Specifications change of Caliber 9T and 9U Series

Specifications change of Caliber 9T Series

Specifications change of Caliber 9U Series

Technical drawing of caliber 9U17

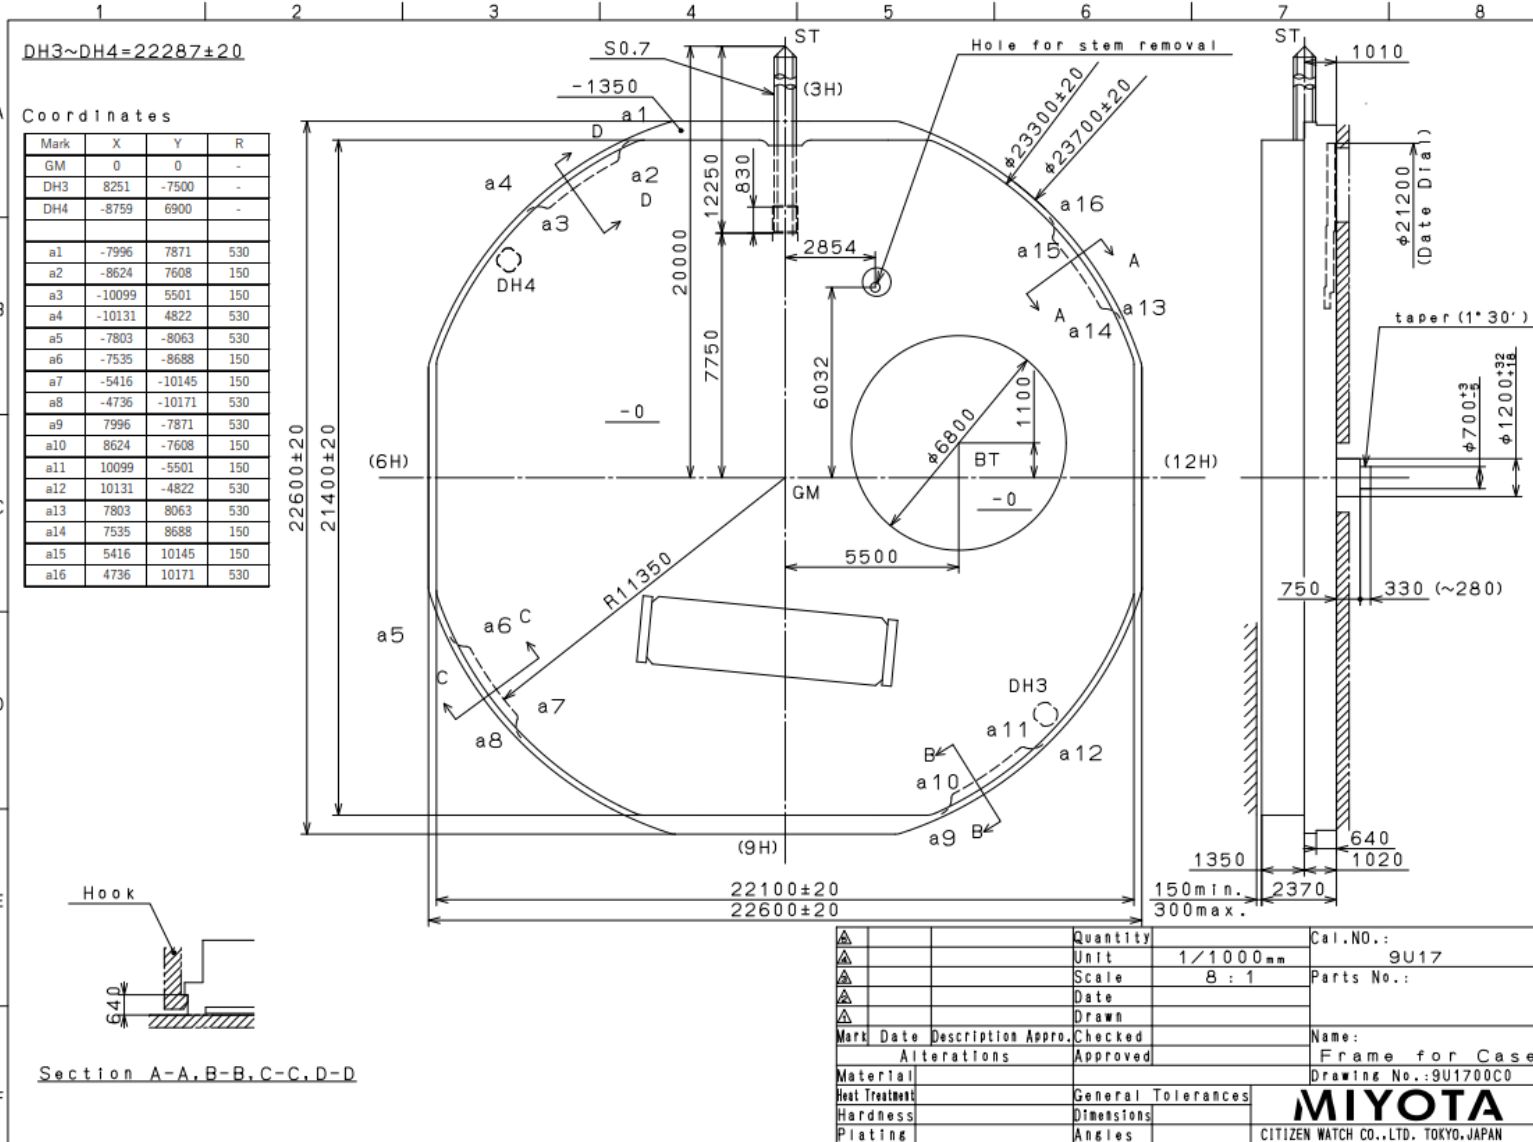
- Exterior components (case, hands and dial) are compatible so they can be used as is.
- The plastic movement holder needs to be redesigned as the one for the 9U15/9U13 is not compatible. Please refer to the drawings in next pages for details.
